Stage 1 Quality Audit Response Document

Proposed Residential Development at Anglesea Terrace,  
Old Station Road, Cork

H105-CSC-ZZ-XX-RP-C-0006

Stage 1 Quality Audit

#### A.1.1 Tactile Paving Stem

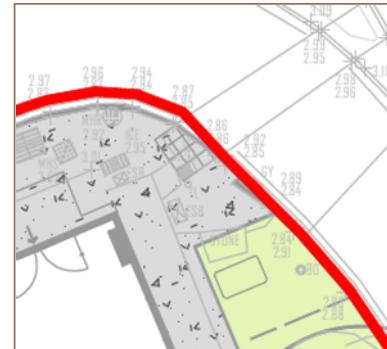
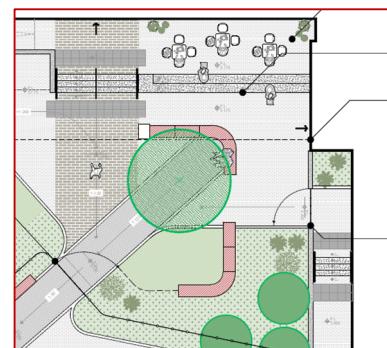
The stem of the tactile paving at the existing signalised pedestrian crossing on the western side of South City Link Road does not extend to the back of the footpath. This may lead to visually-impaired pedestrians travelling at the back of the footpath being unable to detect the tactile paving and subsequently the crossings resulting in them being unable to safely and independently navigate the road layout.

The stem of the tactile paving should extend to the back of the footpath at the location of the crossing.

The stem of the tactile paving has been extended to the back of the footpath at the location of the crossing as recommended. Please refer to CS drawing no. **H105-CSC-XX-XX-DR-C-0013**.

#### A.1.3 Absence of Mobility Impaired Parking Spaces

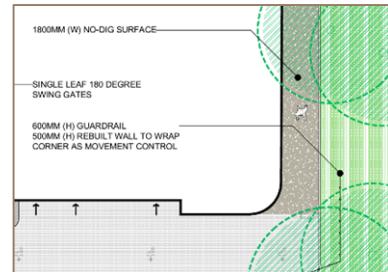
It appears from the drawing that there are no mobility impaired parking bays proposed within or in close proximity to the development. In a development of this scale it may be necessary to cater for mobility impaired users. This may result in mobility impaired users or passengers having to park a significant distance from the development.

An assessment should be carried out to determine if a mobility impaired parking space is required.

It is not proposed to provide any mobility impaired parking spaces as part of the proposed development, and this has been agreed with Cork County Council.

#### A.1.5 Absence of Dropped Kerbs

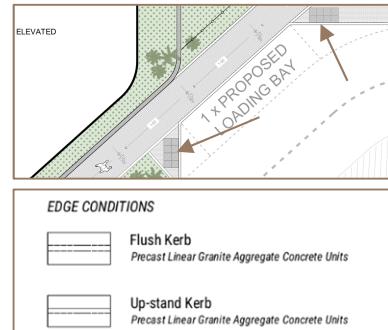
Dropped kerbs, where tactile paving arrangement is proposed, has not been indicated at the loading bay on the western side of Anglesea Terrace, so it is unclear how mobility impaired vehicle occupants will travel between the parking space and the adjacent footpath.

Ensure mobility impaired users can safely travel between the parking spaces and the adjacent footpath.

Dropped kerb shall be provided at the locations of tactile paving to ensure that the mobility impaired users can safely travel between the parking spaces and the adjacent footpath.

#### B.1.2 Overhanging Trees

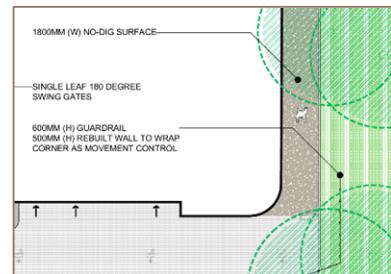
Trees are indicated as overhanging the footway located on the eastern side of the development. The specification of tree is unclear, but low hanging canopies may increase the risk of head strikes, leading to personal injury.

Ensure tree canopies are at least 2.3m above the footway, or 2.5m if cyclists are expected to use the pavement.

These canopies are of existing trees, and will be subject to BS5837 trees in relation to design, demolition and construction. It is understood that the existing canopy is notably above head clearance height, and any local pruning shall be coordinated and conducted by trained arboriculture specialist.

### 3.1 Tactile Paving Stem

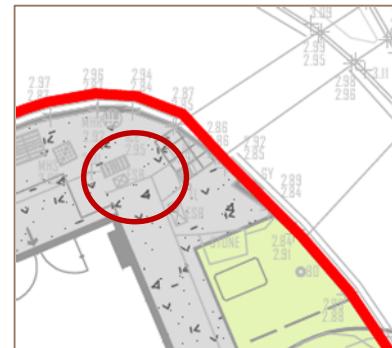
Summary: *The stem of the tactile paving at the signalised pedestrian crossing on South City Link Road at its junction with Old Station Road does not extend to the rear of the footpath.*

The stem of the tactile paving at the existing signalised pedestrian crossing on the western side of South City Link Road does not extend to the back of the footpath. This may lead to visually-impaired pedestrians travelling at the back of the footpath being unable to detect the tactile paving and subsequently the crossings resulting in them being unable to safely and independently navigate the road layout.

The stem of the tactile paving should extend to the back of the footpath at the location of the crossing.

*The stem of the tactile paving has been extended to the back of the footpath at the location of the crossing as recommended. Please refer to CS drawing no. **H105-CSC-XX-XX-DR-C-0013**.*

### 3.4 Absence of Dropped Kerbs

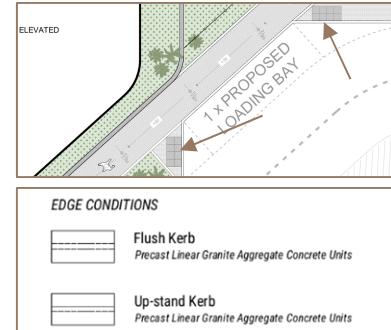
Summary: Dropped kerbs have not been indicated at the tactile paving arrangement adjacent to the proposed loading bays.

Dropped kerbs, where tactile paving arrangement is proposed, has not been indicated at the loading bay on the western side of Anglesea Terrace, so it is unclear how mobility impaired vehicle occupants will travel between the parking space and the adjacent footpath.

Ensure mobility impaired users can safely travel between the parking spaces and the adjacent footpath.

Dropped kerbs have been proposed on both sides of the loading bays to ensure that mobility-impaired users can safely travel between the parking spaces and the adjacent footpath.

### 3.6 Footpath Surface

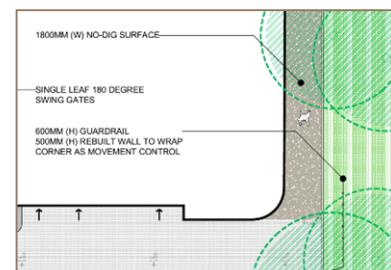
Summary: The use of an unbound surface may result in rutting within the track and a risk of slips, trips, and falls.

The footpath on the eastern side of the proposed development is indicated as 'no dig surface'. It is unclear if this is a bound material. If the surface is not composed of a bound material, it may be more susceptible to rutting and a resulting increased risk of ponding, leading to slips and falls for pedestrians, particularly during wet and icy weather conditions.

The proposed 'no dig surface' should be composed of a bound material.

The no dig surface shall be composed of a bound material.
